ENTRYWAY ROUNDABOUT
REVIEW OF OPERATION & SAFETY

For the City of Clearwater

Robert Barry Crown, B.Sc. C.Eng. M.I.C.E
Rodel Software Ltd

Sign Blocking View to the Left

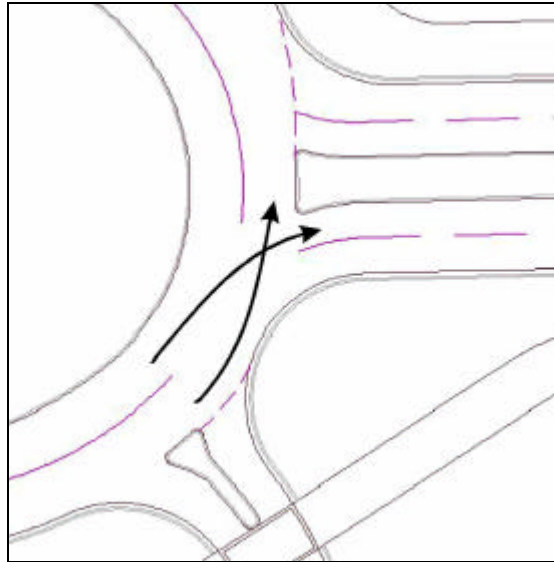
Currently some of these signs are obstructing the view to the left of drivers at the yield line waiting to enter the roundabout. This should be corrected by raising the height of the signs as lowering them make them less visible to the circulating traffic, especially at the Coronado exit where the fountain wall would obstruct the drivers view of a low sign until vehicles are too close to the exit. If the height of the fountain wall is reduced the signs could be lowered and still be visible.

Driving in the outer lane across the Causeway Exit and crossing the path of an exiting vehicle from the inner lane

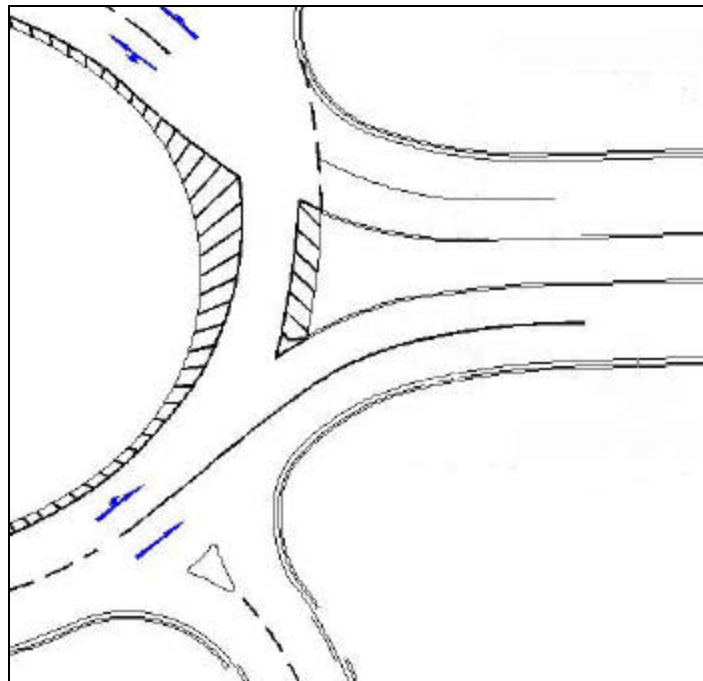
It is incorrect and dangerous for drivers to use the outside lane of the roundabout to cross a **multiple-lane exit**. However, some drivers from Coronado or Mandalay are using the outside lane to pass the **two-lane exit** at the Causeway.

These vehicles cut across vehicles on the inner lane of the roundabout that are correctly exiting onto the Causeway. This has led to a concentration of crashes at this location.

The central striping on the circulating pavement around the roundabout is a solid line with occasional short breaks. This discourages drivers in the outer-lane, who wish to turn across the Causeway exit, from gradually merging into the inner lane. They either make a sudden lane change at the break in the solid line or inappropriately stay in the outer lane.

Approaching the Causeway exit, the **left curved** geometry of the outer curbing, together with the large exit angle and small exit radius onto the Causeway, combine to give drivers the strong impression that driving past the Causeway exit in the outer lane is natural and correct.

Modifications to the exit geometry, the striping, the lane signs together with the addition of lane direction arrows, will make it clear to drivers that the outer lane is solely for exiting onto the Causeway. Drivers will cease to travel past the Causeway exit in the outer lane, or in rare cases when they realize they are in the wrong lane, they will take extreme caution to avoid collision with exiting vehicles.

(ii) The Exit into Coronado Drive

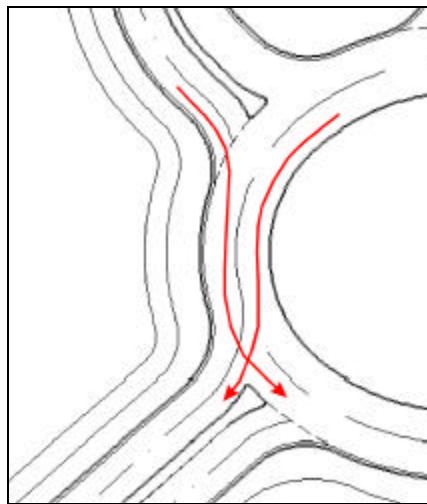
Coronado Drive has a two-lane exit to accommodate the large traffic volumes from the Causeway. It cannot be reduced to a single lane exit without creating very severe congestion.

Some vehicles from the Causeway and Poinsettia are incorrectly using the outer lane of the roundabout to pass the **two-lane** exit at Coronado. Changes to the signing and striping will effectively encourage such traffic to use the correct inner lane. However, the greater part of the traffic that crosses the Coronado exit in the outer lane is from Mandalay Avenue. Crashes occur when both the Mandalay traffic and the circulating traffic behave correctly. The problem is created primarily by the roundabout geometry.

Exit conflict at the exit into Coronado Drive.
The white car exits into Coronado across the path of the non exiting red car

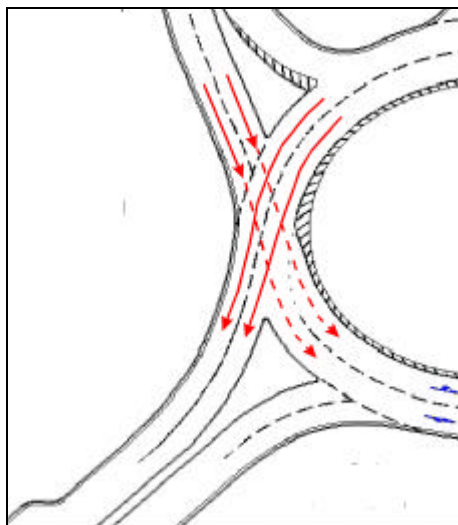
Crashes occur at this exit when a vehicle using the inner lane of the roundabout turns right into Coronado Drive and cuts across the path of a non-exiting vehicle in the outer lane of the roundabout.

When a vehicle is on the inner lane of the roundabout, and the outer lane is empty, a vehicle from Mandalay can **safely** enter the outer lane of the roundabout **without yielding**.

The paths of the two vehicles **do not cross**. The Mandalay vehicle makes a **merge** into the outer lane with no **entry conflict** with the inner lane vehicle. This is very undesirable as the absence of the **entry conflict** can subsequently create a dangerous **exit conflict**.

The two vehicles proceed **side by side** for about 75ft until they reach the exit of Coronado. If the outer vehicle proceeds when the inner vehicle exits, their paths suddenly cross creating an

exit conflict and a crash is likely to occur. Neither has priority over the other, nor do they know the others intention until the last second, when it can be too late.

This problem can be resolved by modifying the entry and the exit geometry between Mandalay and Coronado, removing the 75ft 'reverse curve' parallel **side by side** section between the entry and the exit. This will stop the entry **merge** and cause all Mandalay traffic to **yield** to traffic on both the inner and outer lanes the roundabout.

With this new arrangement, the **exit conflict** is replaced by the much safer **entry conflict** where the traffic exiting into Coronado has absolute and unambiguous priority over the Mandalay Traffic. Consequently all the Mandalay traffic will yield to all the circulating and exiting traffic. As a result, vehicles from the roundabout will exit safely into Coronado **before** the Mandalay traffic enters the roundabout. **This will virtually eliminate exit accidents at Coronado Drive.**
